ADDENDUM #1

Reference: Boiler and Economizer Installation
Weber State University - Ogden, Utah
DFCM Project No. 07049810

Project Name: Weber State University
Heating Plant - Boiler Replacement

Addendum No.: 1

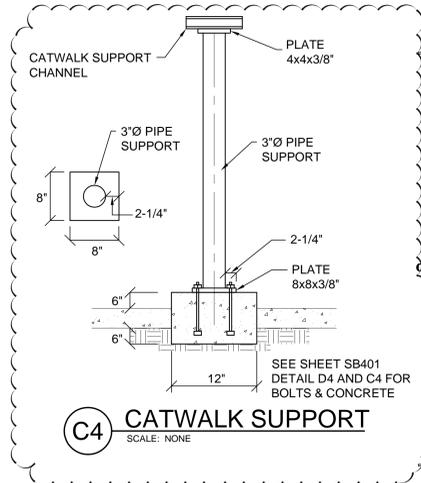
- Item VI-5.** Sheet ME101 and ME901 Detail C3. During demolition the gas piping was not removed as required by the drawings; therefore this contractor shall remove the two gas lines, that served existing removed boilers 1 & 2, back to the main gas line at the wall and cap. This contractor shall make new 3 inch piping connection to the existing main gas line complete with new 3 inch plug valve. Note 2 sheet ME901 shall read "Connect new 3 inch gas piping to

header. Field verify exact location of new tie-in." Note 6, sheet ME901 shall read "Provide new 3"-150# flg'd plug valve". Note 37, sheet 901 shall read "Remove existing gas piping back to main and cap." Note 5, sheet ME 101 shall read "Connect new 3 inch gas piping to existing header." Field verify exact location."

SHEET NO. **ME202**

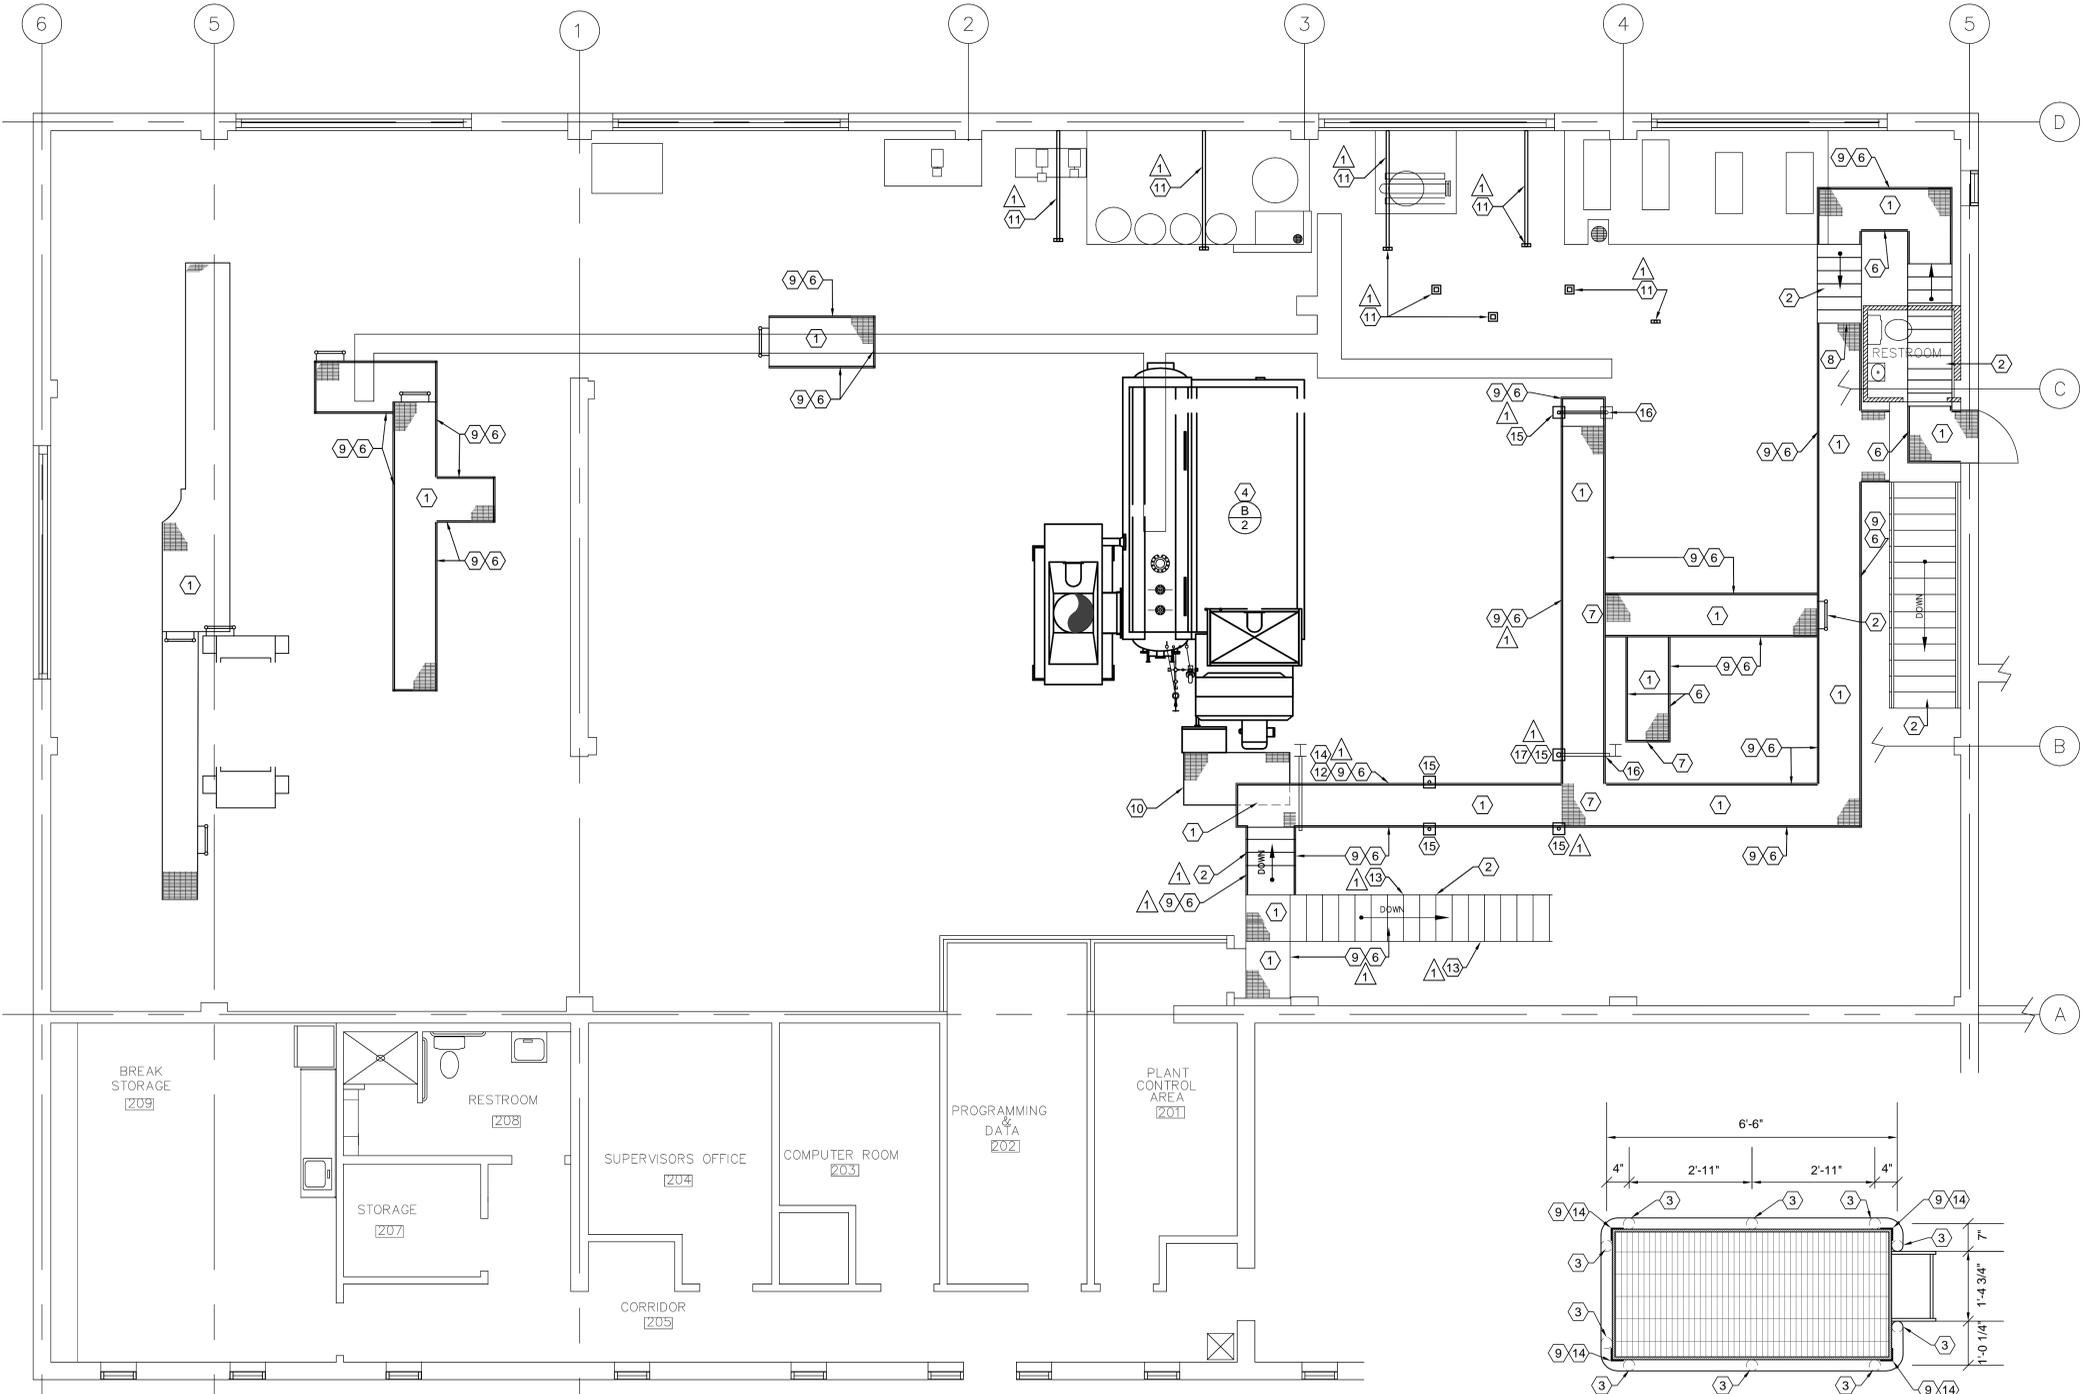
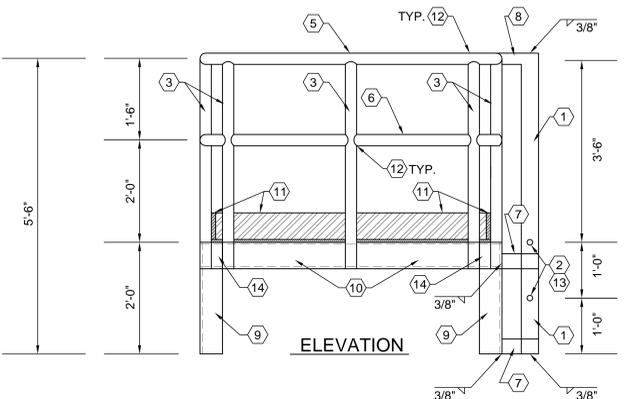
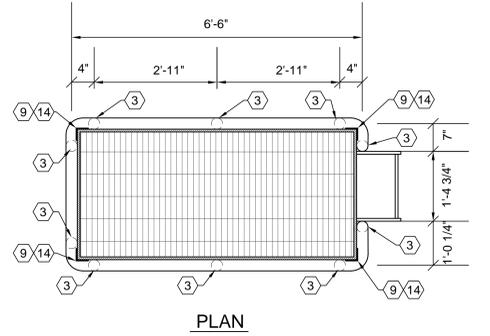
- Item VI-8.** During the demolition, the contractor provided temporary supports for the existing catwalks. This contractor shall remove these temporary supports and replace these supports. The temporary support off the I-beam column shall remain. A new drawing ME202 is issued in this addendum to replace the previous ME202. This drawing directs the contractor how to support the existing catwalks.

- Item VI-9.** During the demolition, the contractor provided temporary supports for the existing piping located along the west wall. This contractor shall remove these temporary supports and provide new supports according to the specifications. New supports shall not take away access to new and existing equipment and piping, See new ME 202 noted in item VI-8 above for locations of temporary pipe supports.

MARK	DATE	REVISION
△	06/06/08	REMOVE AND REPLACE TEMPORARY PIPE SUPPORTS-ADDENDUM No. 1
△	06/06/08	REMOVE AND REPLACE EXISTING CATWALK SUPPORTS-ADDENDUM No. 1

SHEET NO. **SB101**

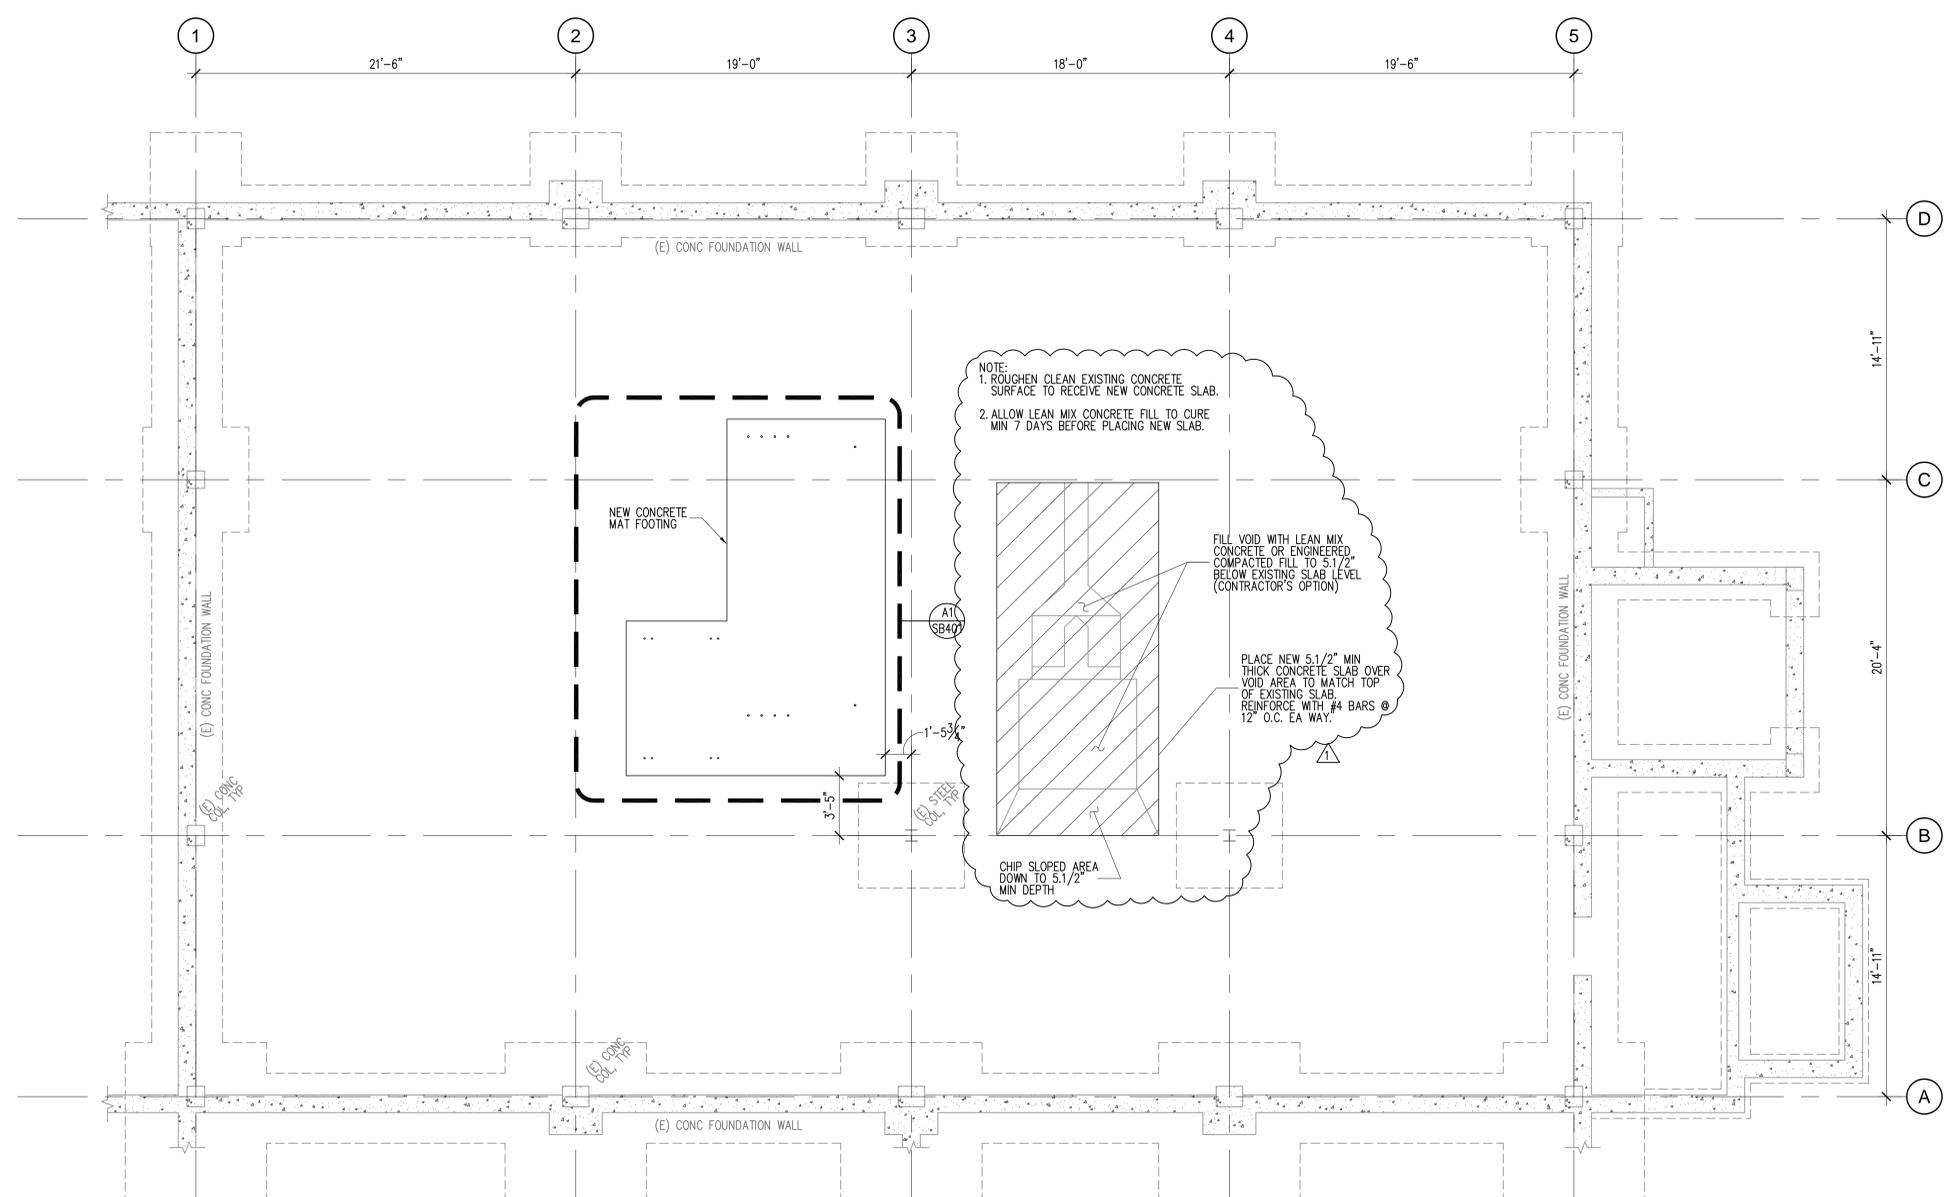
- Item VI-7.** During demolition for boiler #1 an air passage under the floor was discovered. A new drawing SB101 is issued in this addendum to replace the previous SB101. This drawing directs the contractor how to fill and cover the under floor trenches.

- Item VI-11.** Sheet SB101. The existing concrete floor area under the new boiler footing shall be chipped down to the correct dept before placing new footing and pad.

Lean Mix Concrete Backfill:

1. Contains maximum of 94 lbs of cement per cubic yard of slurry fill/backfill.
2. Minimum stable air content of 20 percent, Darafill dosage as necessary.
3. maximum water content of 36 gallons per cubic yard of backfill.
4. Maximum compressive strength of 150 psi at 28 days.
5. Type Two Acceptable Products:
 - a. Dara fill by W R Grace & Co. Cambridge, MA www.na.graceconstruction.com
 - b. Equal as approved by Architect before use. See Section 01 6200.
